## FORD E4OD "UPDATE HANDBOOK"

### INDEX

Figure 37

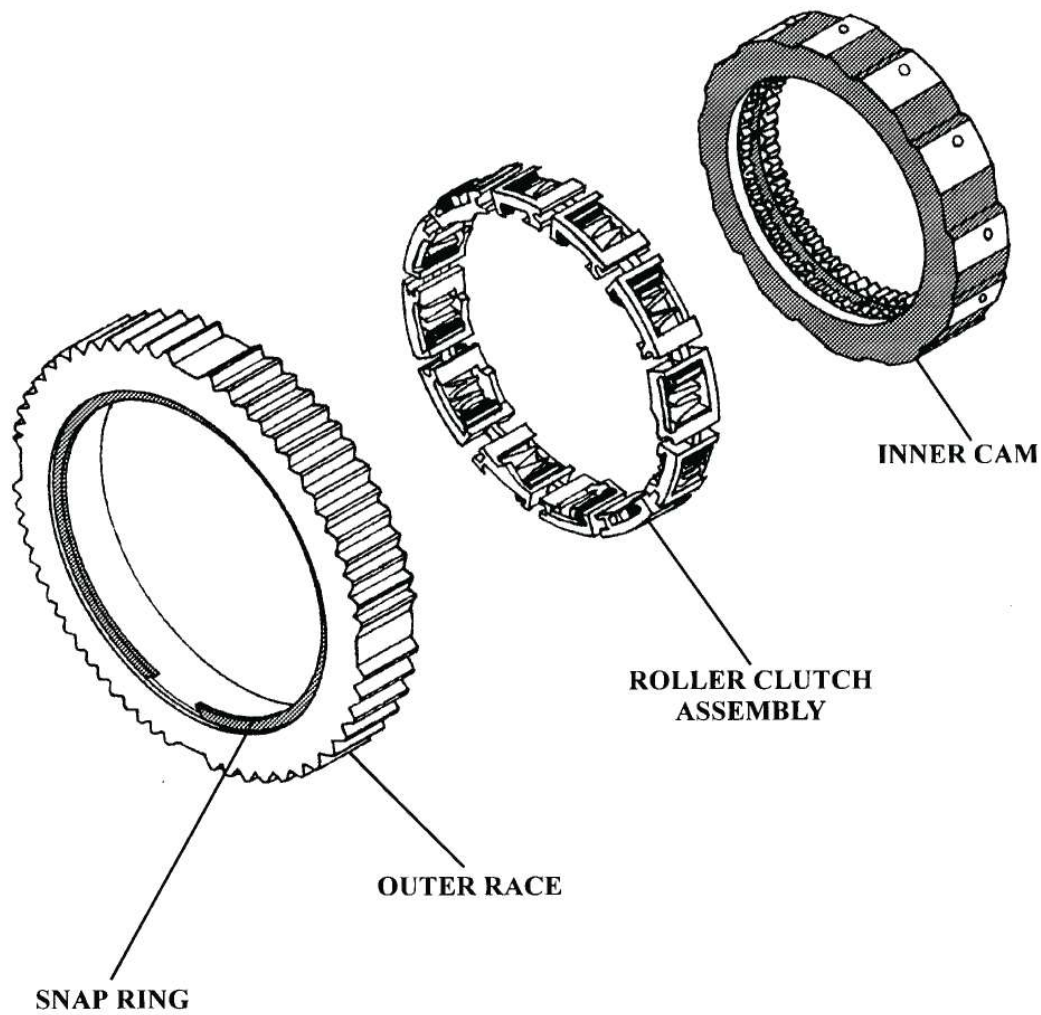
The previous design Overdrive Sprag (E9TZ-7A089-A) **is no longer available**. The previous part number will now supercede to one of the part numbers listed below under "Service Information", as there is one number for F-Super Duty and Motorhomes and another number for all others. The new design "Overdrive Roller Clutch Service Kit" will retro-fit back on **all** previous models (See Figure 37).

Figure 38

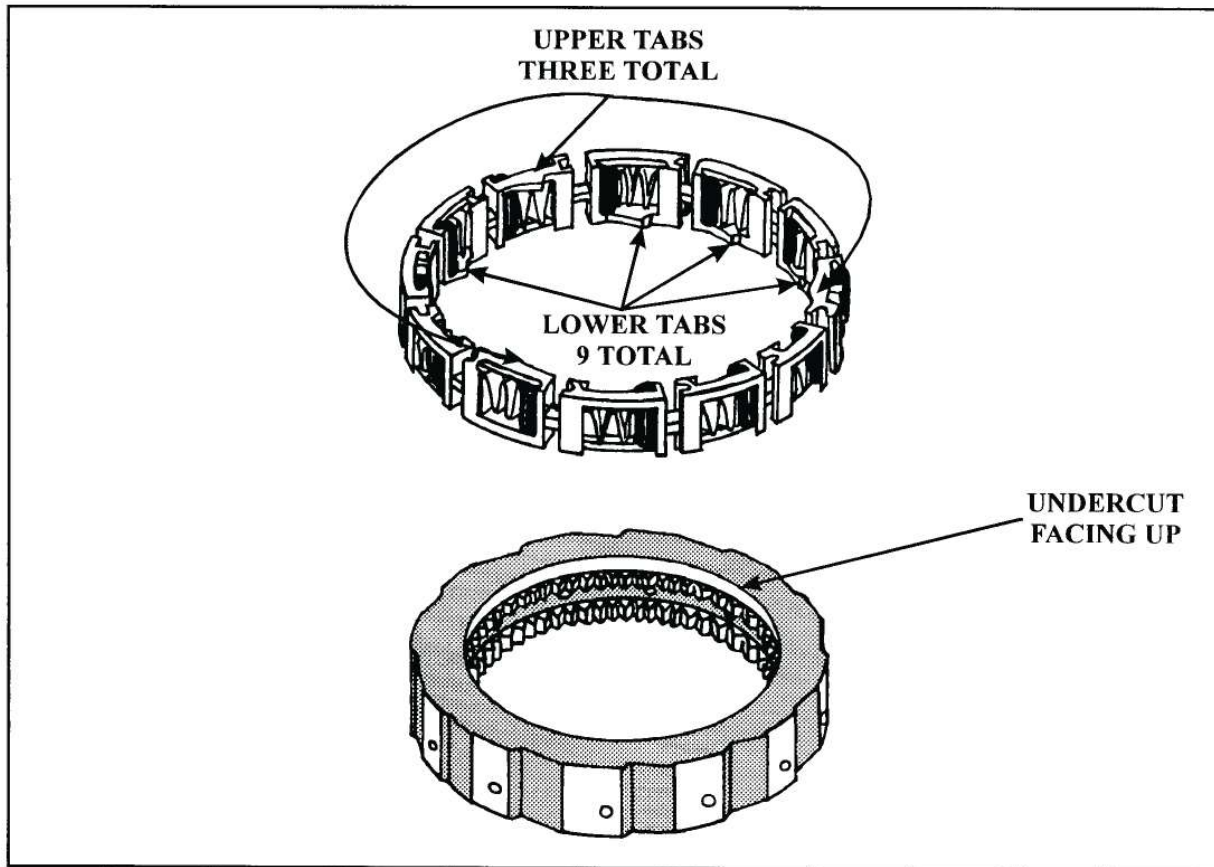
- (1) Place the new inner cam on a flat work surface with the "Undercut" on the inside diameter facing **up**, as shown in Figure 38.
- (2) Install the overdrive roller clutch assembly over the inner cam, **with the 9 locking tabs on the inner diameter facing down, and the three upper locking tabs facing up**, as shown in Figure 38.
- (3) Push the overdrive roller clutch assembly all the way down, as shown in Figure 39.
- (4) Install the snap ring into the groove in the outer race, as shown in Figure 40.
- (5) Install the outer race assembly over the overdrive roller clutch, by holding the inner cam and rotating the outer race in a clockwise direction, until fully seated, as shown in Figure 41.

Figure 42

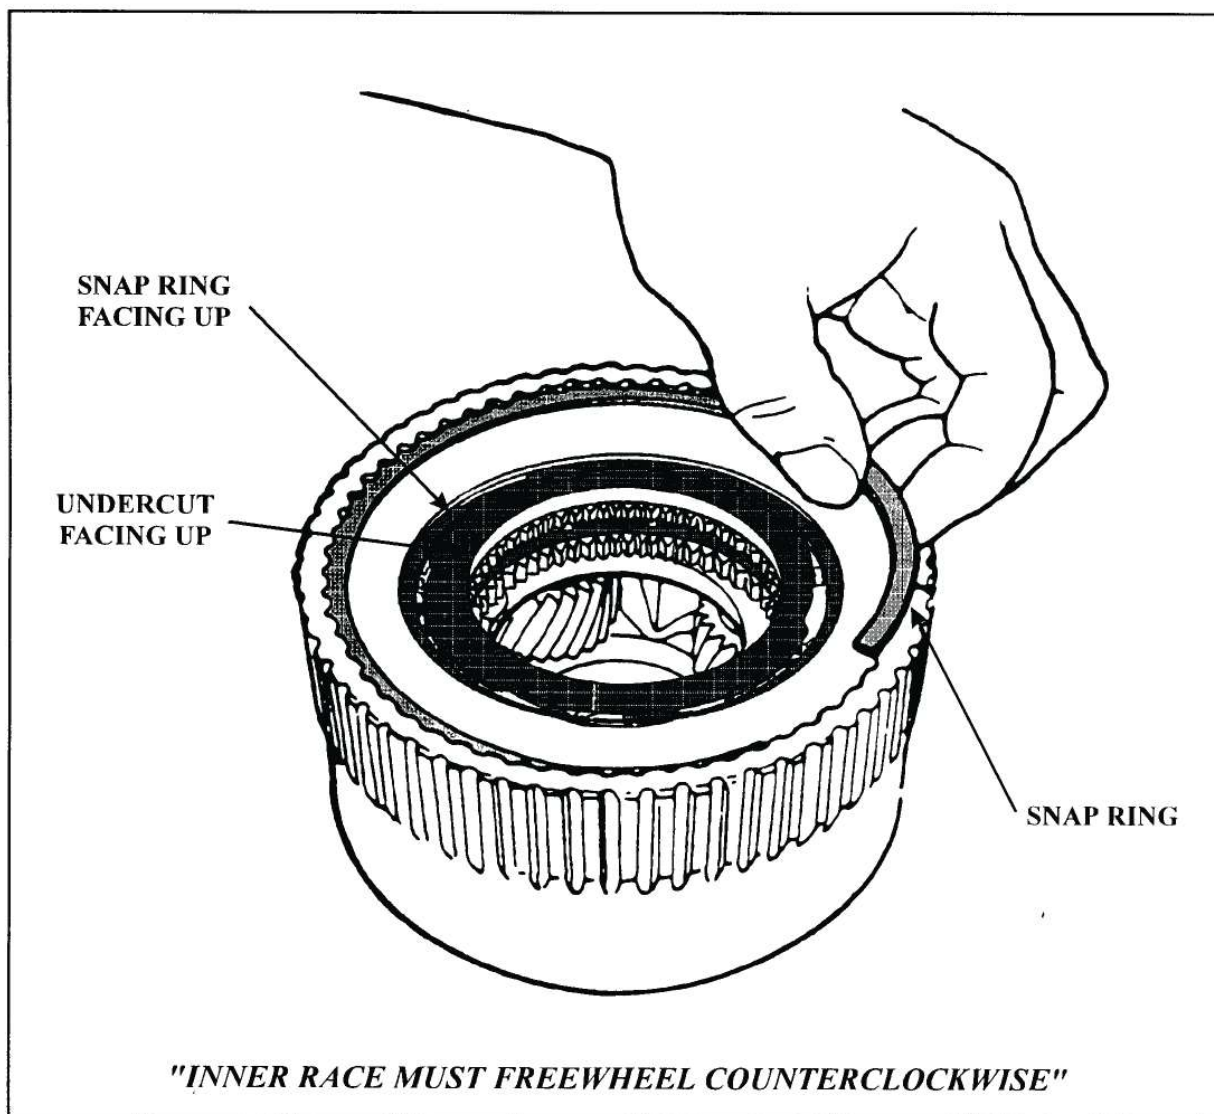
- (6) Install the completed Overdrive Roller Clutch Assembly into the overdrive ring gear, with the snap ring and the inner cam undercut, **facing up**, and install the outer race to ring gear snap ring, as shown in Figure 42.

Figure 43

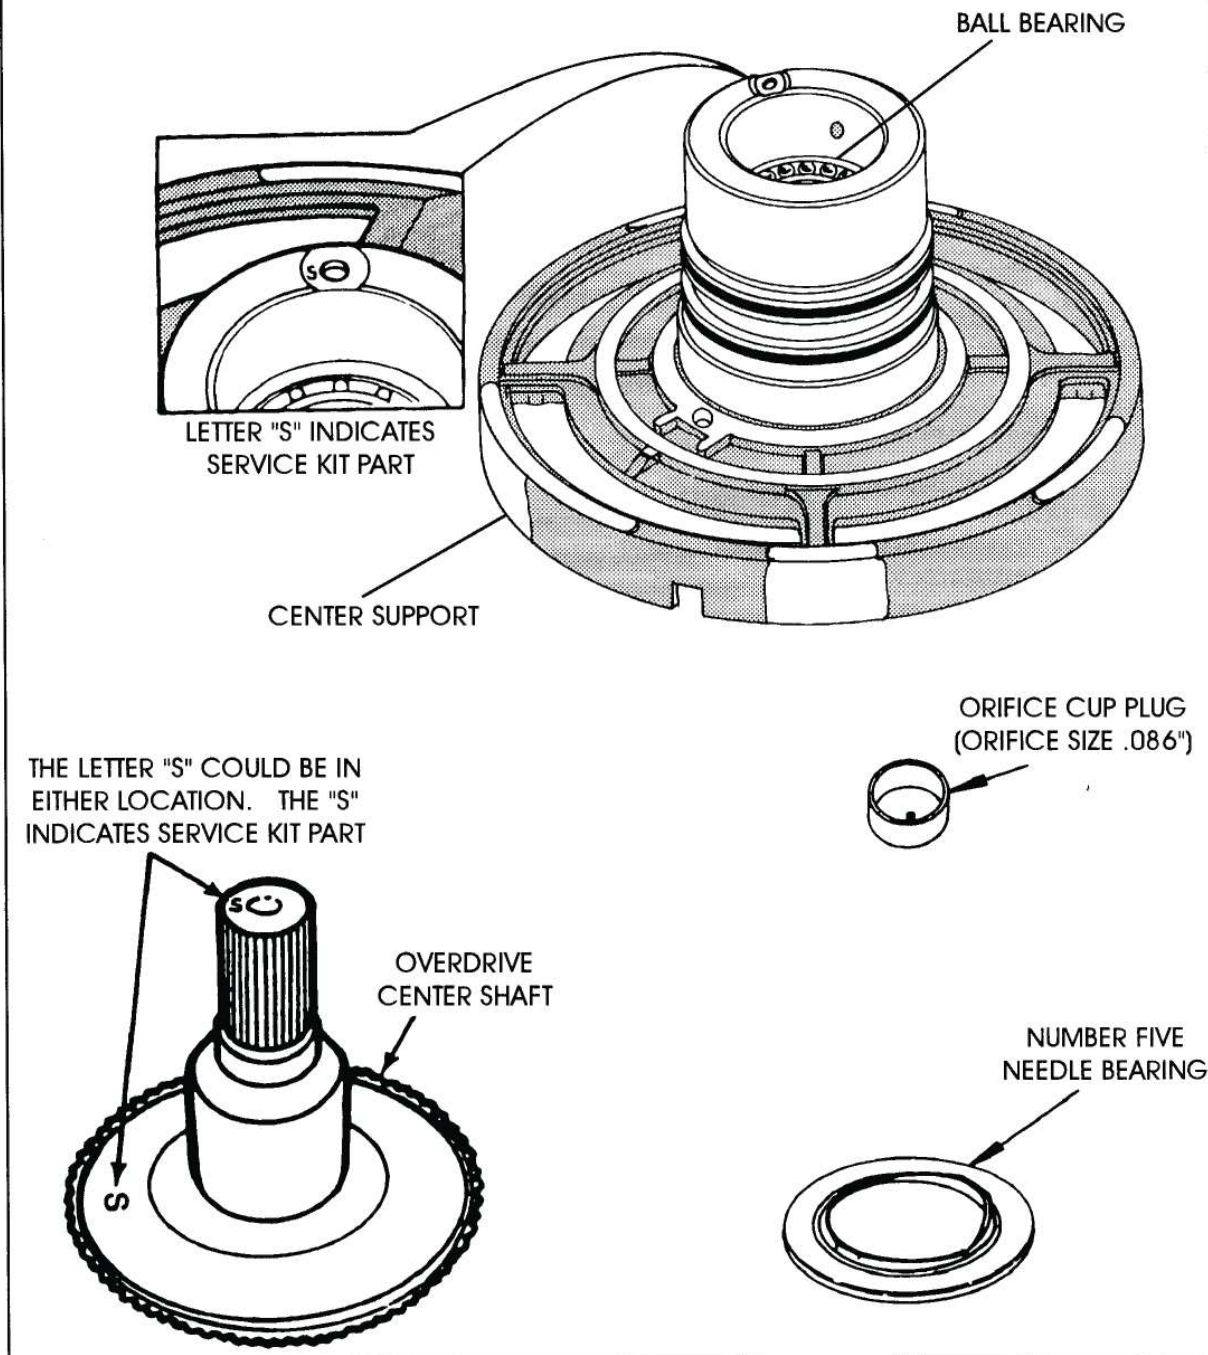
**CHANGE:** There is now available, from Ford Motor Co, a new design Center Support Service Kit with a ball bearing in the support. The new design service package is available under OEM part number F4TZ-7A130-B, and will back service all past model 89-94 E4OD transmissions only. The parts in this service kit are different dimensions than 1995 model year production parts. Refer to Figure 43 for service package kit contents.

Figure 44  
 AUTOMATIC TRANSMISSION SERVICE GROUP

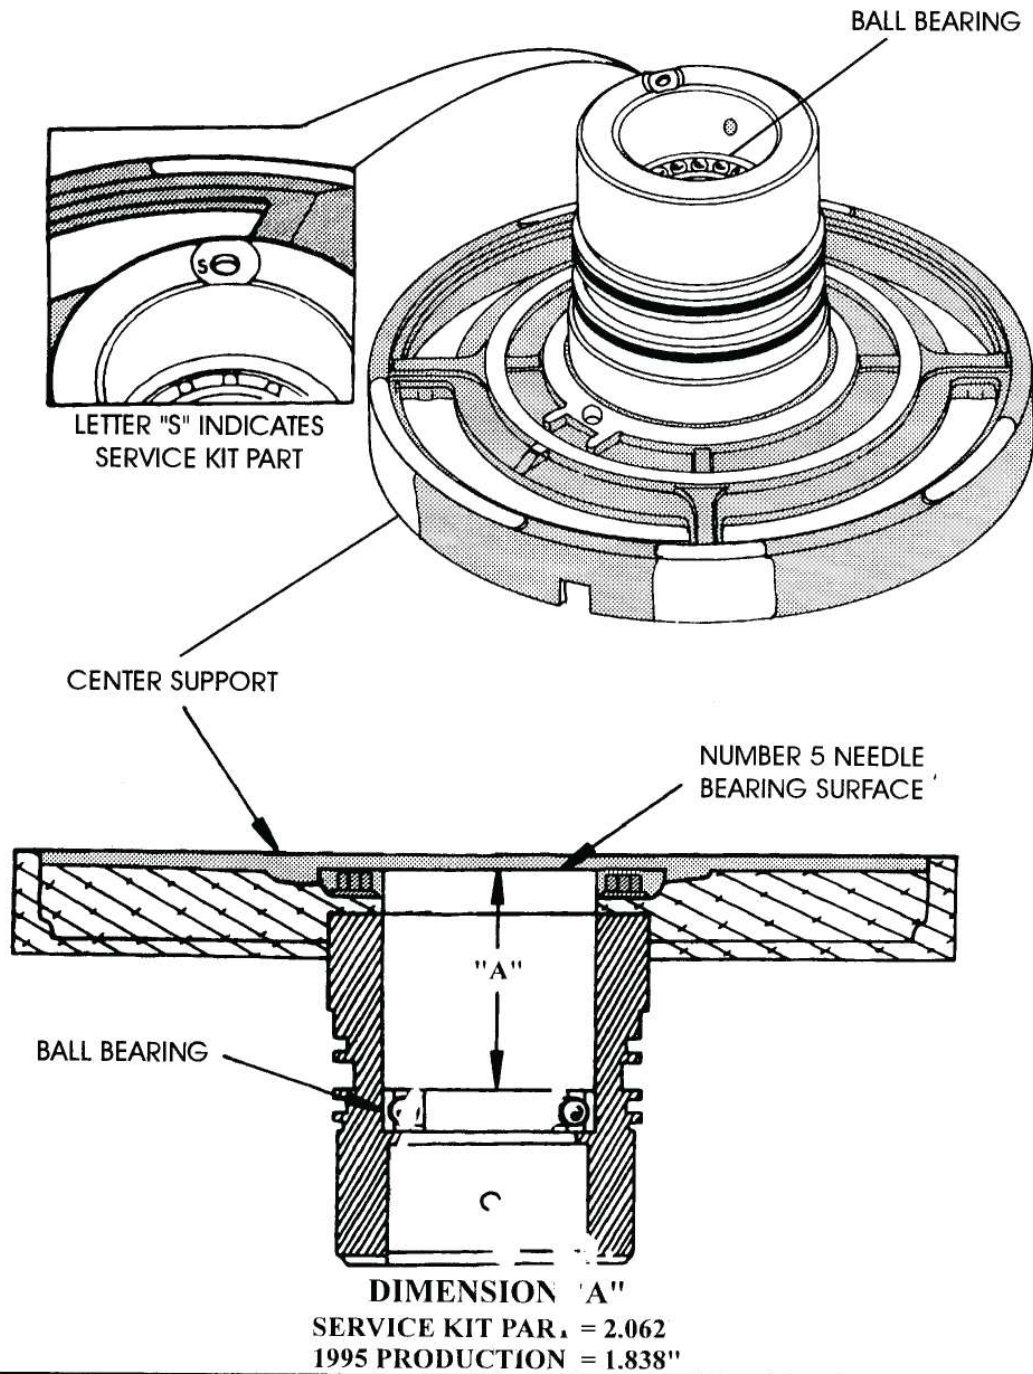
- (1) **CENTER SUPPORT** - Different machining dimensions on the inside bore, to accommodate an added ball bearing that will now support the overdrive center shaft. The new design ball bearing support can be identified as a "Service Part", by the letter "S" stamped on hub, in the location shown in Figure 44. The Service Kit Ball Bearing Center Support has different dimensions than the 1995 production ball bearing center support. Refer to Dimension "A" on the cutaway drawing shown in Figure 44.

Figure 45

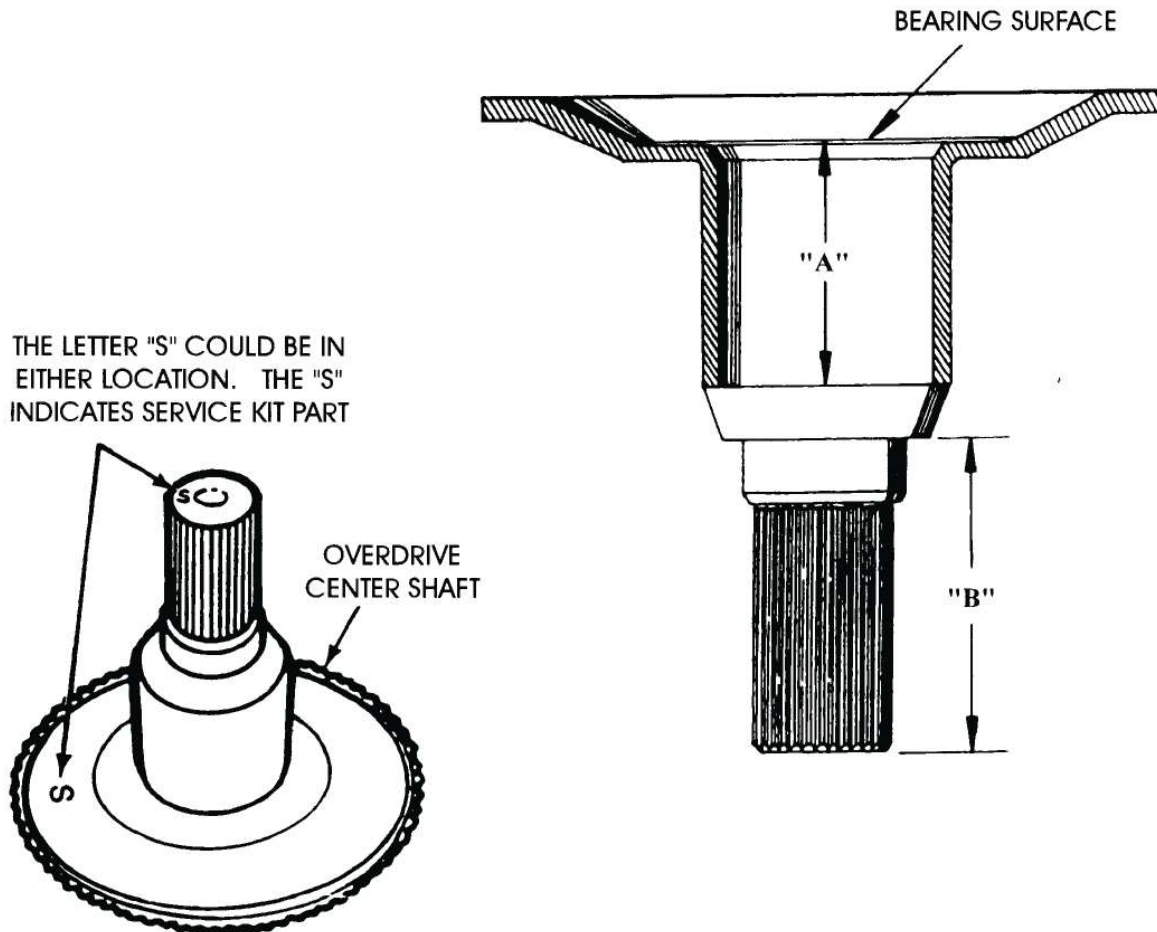
- (2) **OVERDRIVE CENTER SHAFT** - Different machining dimensions on the center shaft to accommodate the added ball bearing, and the pilot on the center shaft has been removed. The new design Overdrive Center Shaft can be identified as a "Service Part", by the letter "S" stamped on the shaft in one of two locations, as shown in Figure 45. The Service Kit Overdrive Center Shaft has different dimensions than 1995 model year production center shaft. Refer to Dimensions "A" and "B" in the cutaway drawing shown in Figure 45.

Figure 47  
AUTOMATIC TRANSMISSION SERVICE GROUP

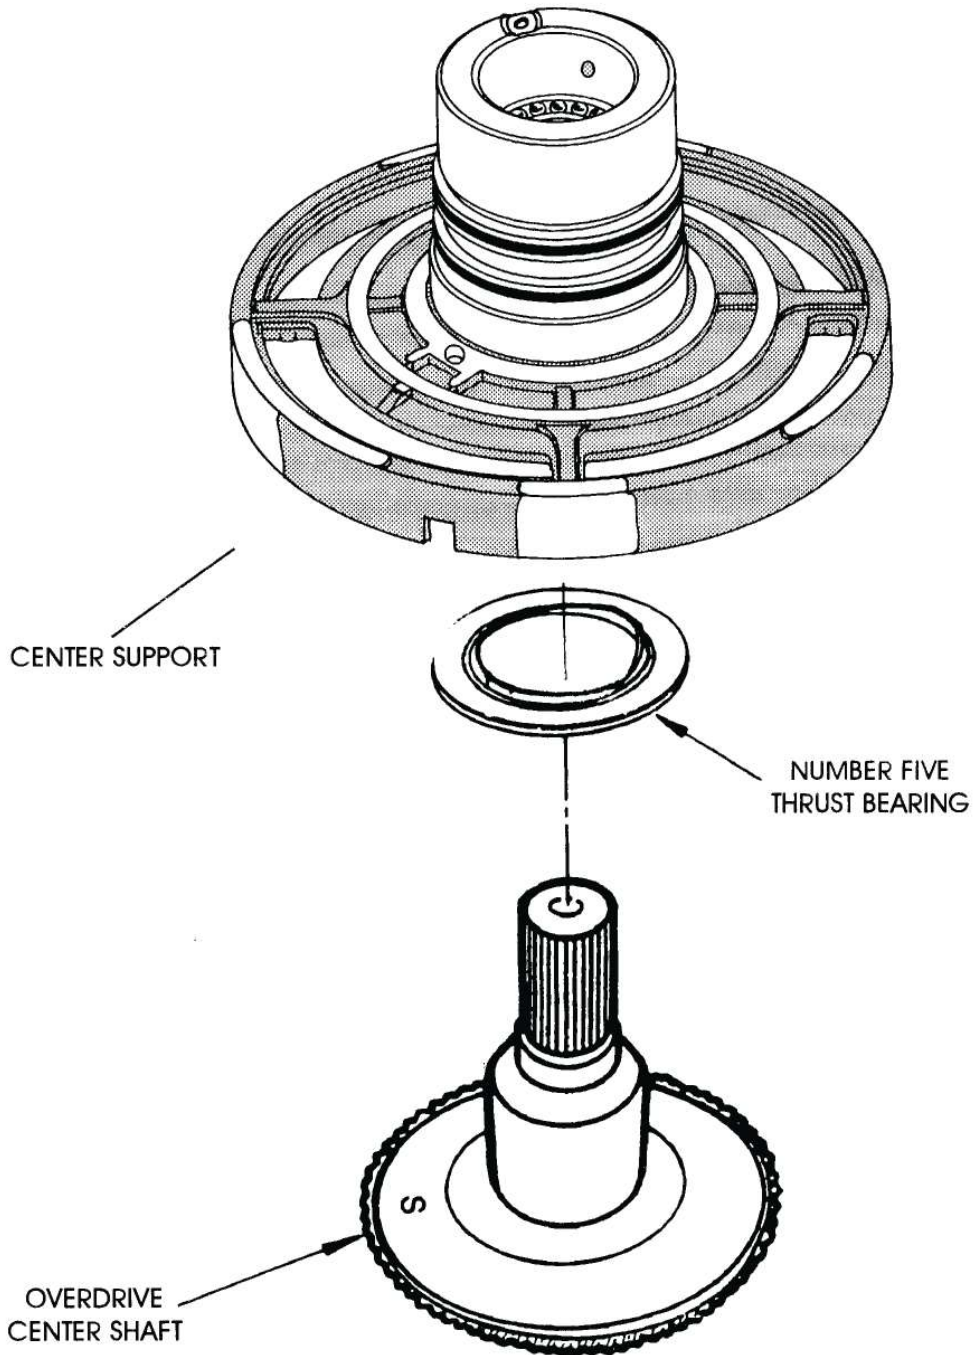
- (4) NO. 5 NEEDLE BEARING - Make certain the No. 5 Needle Bearing included in the service kit is installed with the service kit **regardless** of whether your unit had one or did not have one. Some 1994 model year transmissions were built with some or all of the parts that "Resemble" the parts in this service kit, and may or may not have a No. 5 needle bearing. Make certain that the No. 5 needle bearing from the service kit is installed. Refer to Figure 47 for proper installation of the needle bearing.
